SERVICE BULLETIN

N° **189-292**

ATA 34 - GLONASS IN REAR KIT INSTALLATION

This Service Bulletin is issued in order to provide the necessary instruction on how to perform the installation of “GLONASS in rear kit” P/N 8G3450F01511.

Figure 8

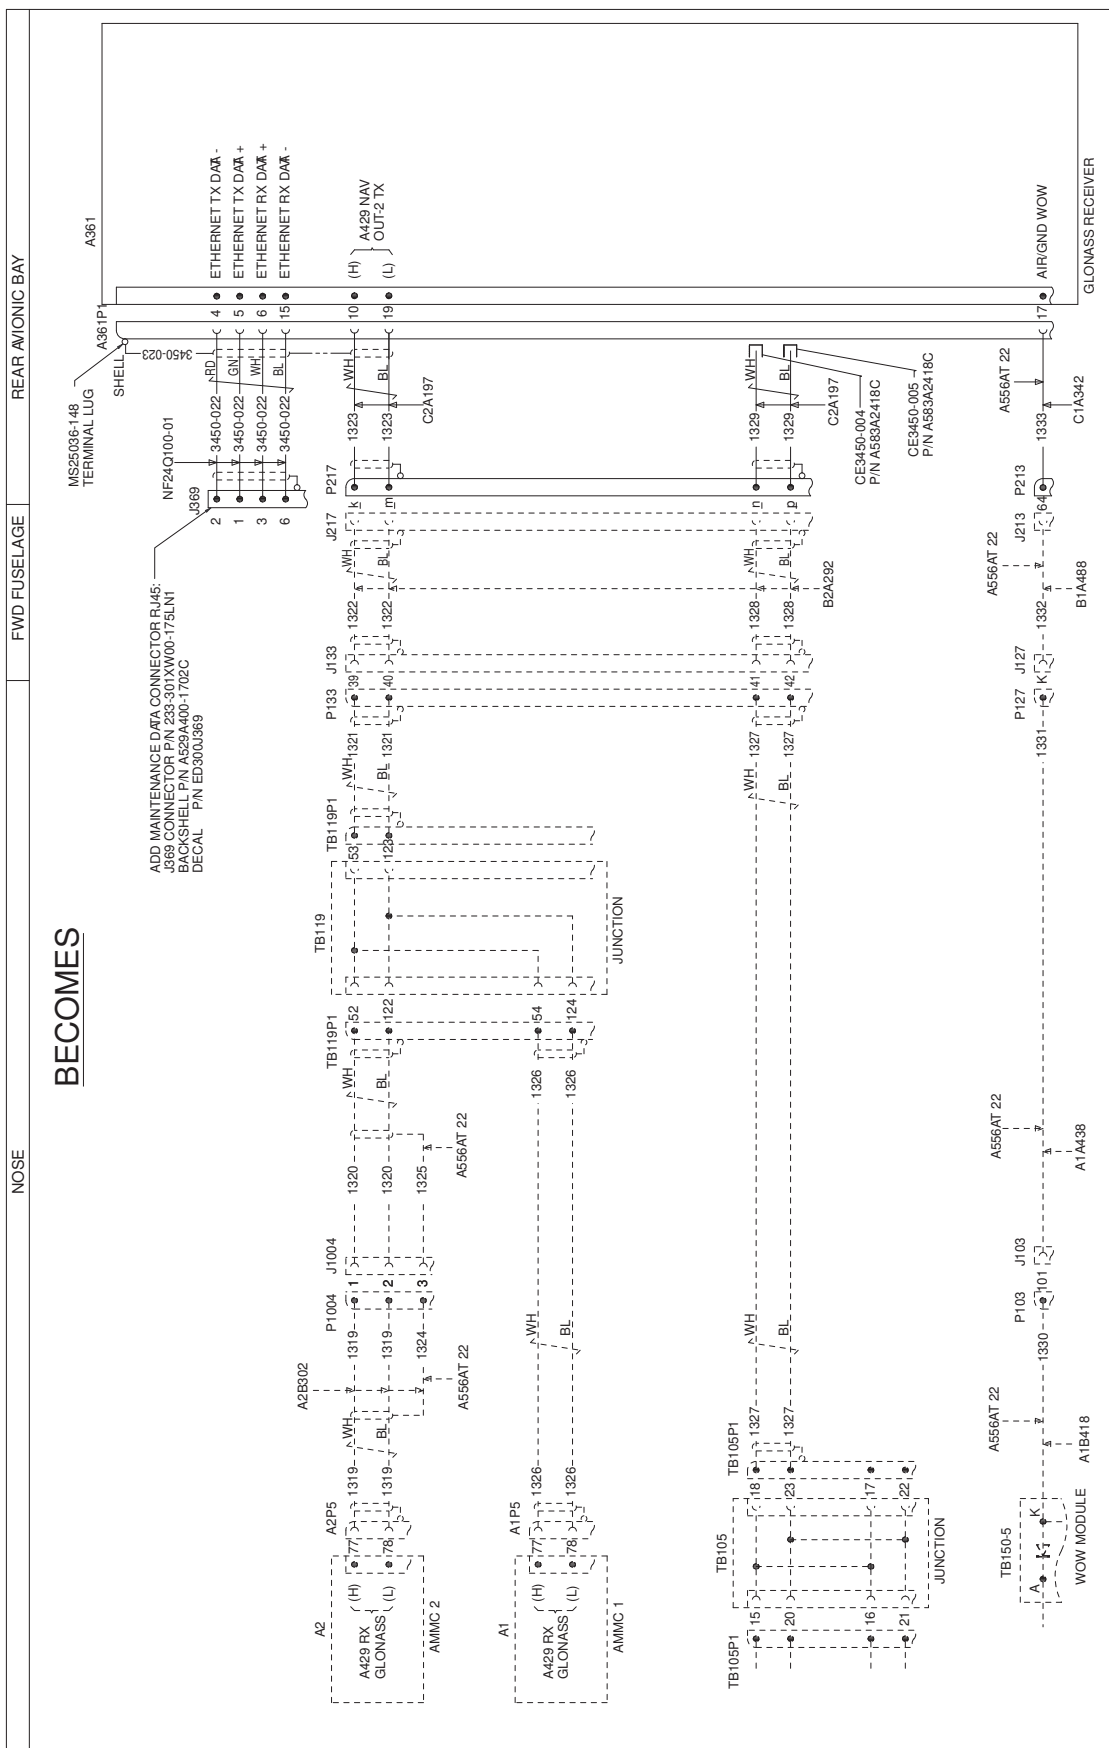
- 4.7 With reference to Figure 4 View A, assemble connector P/N CT15-26S7 and backshell P/N M85049/48-2-2F by means of n°2 screws P/N D20419-21.
- 4.8 With reference to Figure 6 and 8 wiring diagrams (BECOMES), perform the electrical connections shown to the new A361P1 connector. Install n°3 caps P/N A583A2418C on wires 1314 and 1329.

- 4.9 With reference to Figure 8 wiring diagram (BECOMES), lay down a piece of cable P/N NF24Q100-01 of adequate length between the maintenance connector ED300J369 and connector A361P1. Perform electrical connection shown.

- 4.10 With reference to Figure 8 wiring diagram, install on connector A361P1 shell a terminal lug P/N MS25036-148.
- 4.11 With reference to Figure 4 View A and in accordance with AMP DM 89-C-34-56-01-00A-720A-A, install the GLONASS receiver P/N ASD776-AASAXYZ by means of n°4 screws P/N NAS1802-06-6 and n°4 washers P/N NAS1149DN632J. Connect A361P1 connector and A362P2 coaxial connector. In accordance with AMP DM 89-A-11-00-01-00A-720A-A, install decal P/N ED300A361 adjacent to the GLONASS receiver.
